## CT: Invitation for Bids (IFB) 4-2095 "Fence Installation at Pacific Electric Right of Way in Anaheim" Addendum No. 3

## IFB NO. 4-2095 ADDENDUM NO. 3 ATTACHMENT A

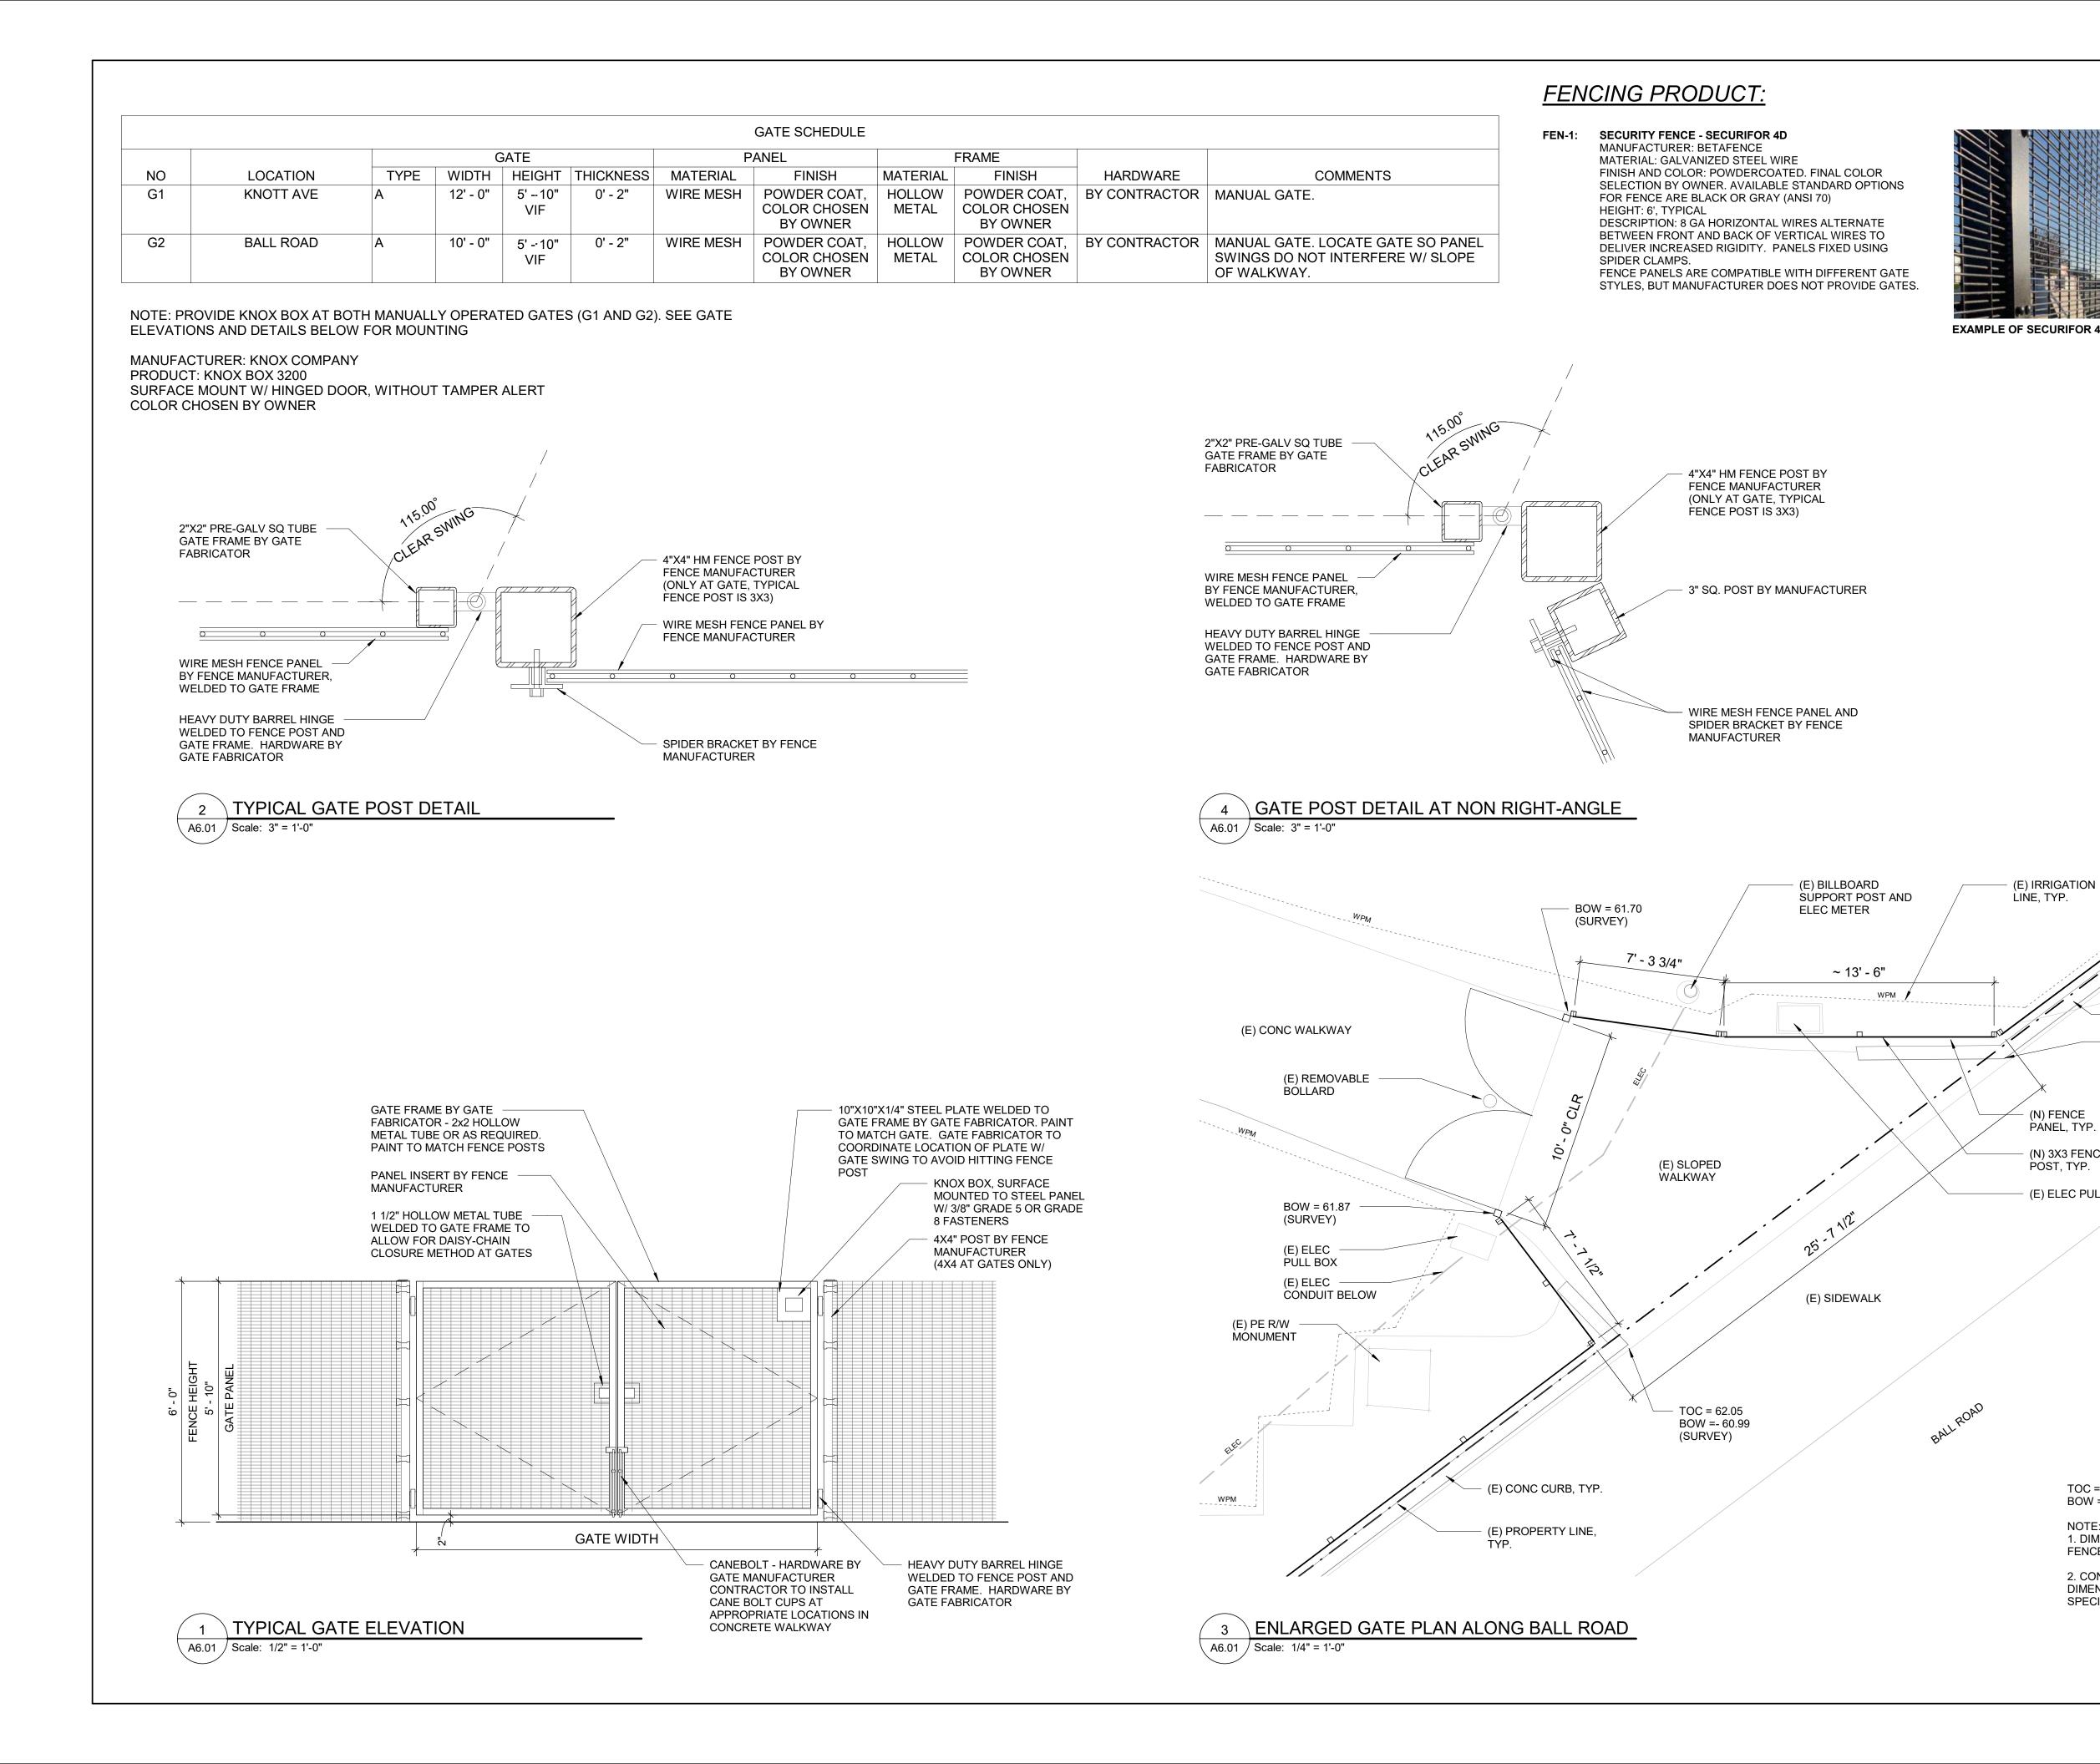
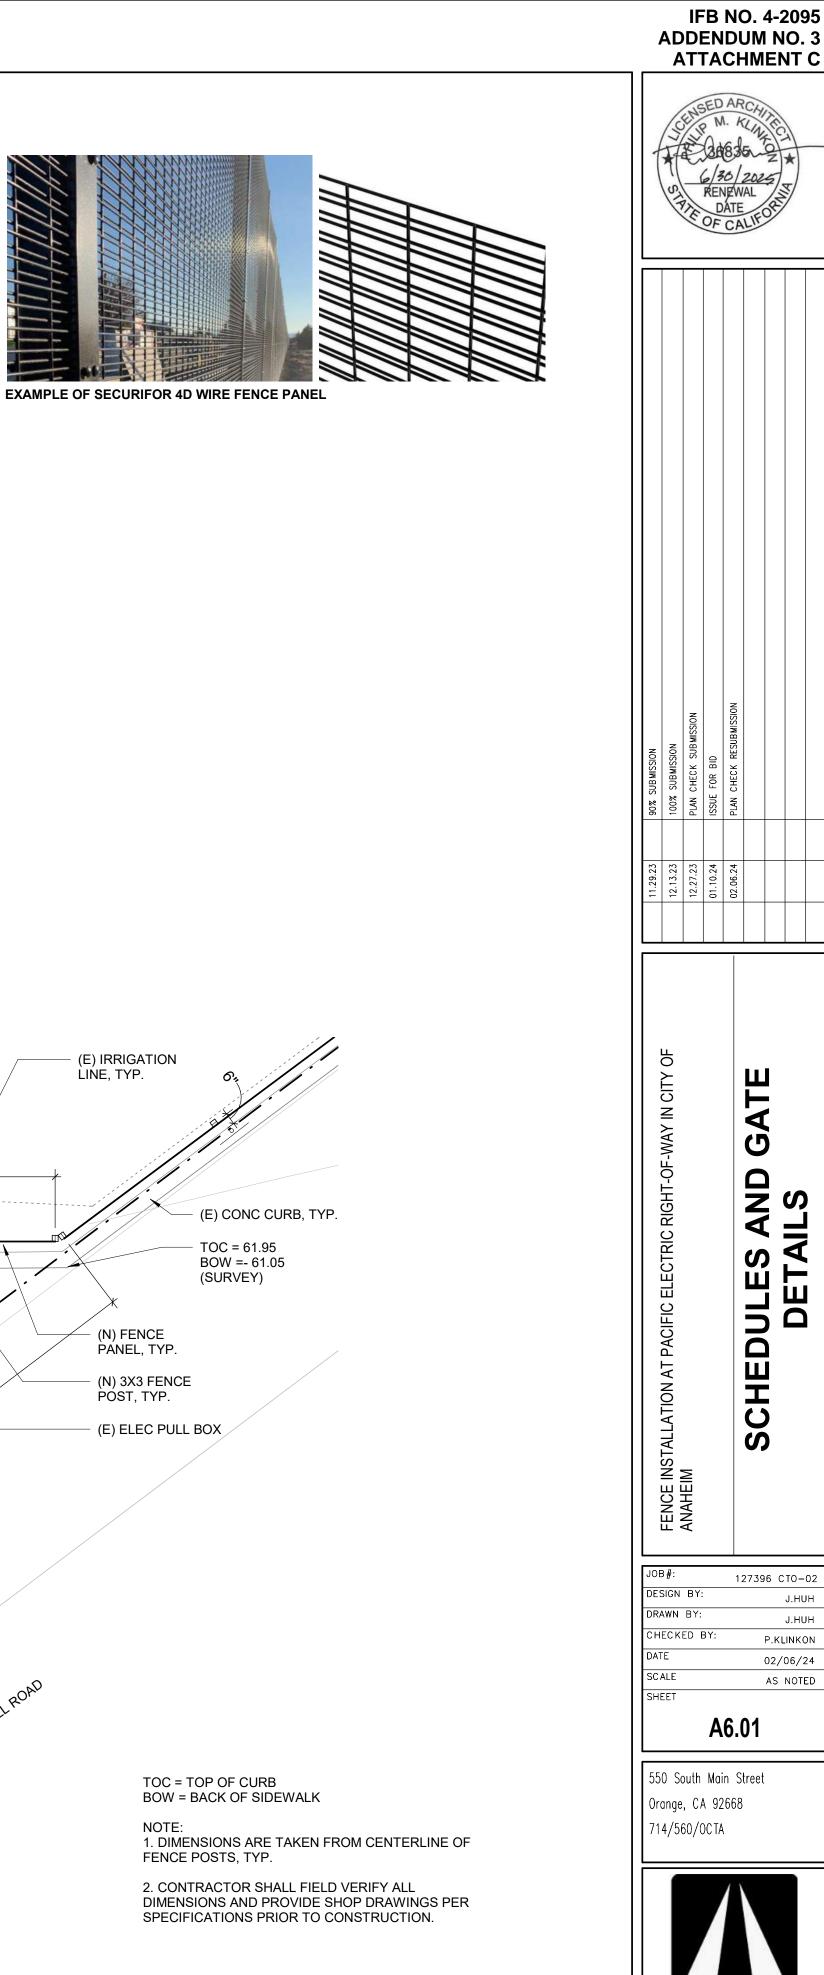
4) There is a Fencing Product (FEN-1) Note stating that Fence Height is 6' typical (Small Section of 7' high panels surrounding swing gates along ball road); however, there is no 7' high panels' detail on the elevation views on detail 3/A2.01. Please indicate the 7' high panels on the elevation view.

A7.4 – The project does not include 7' high panels; please refer to Attachment C – Revised Drawing Sheet A6.01.
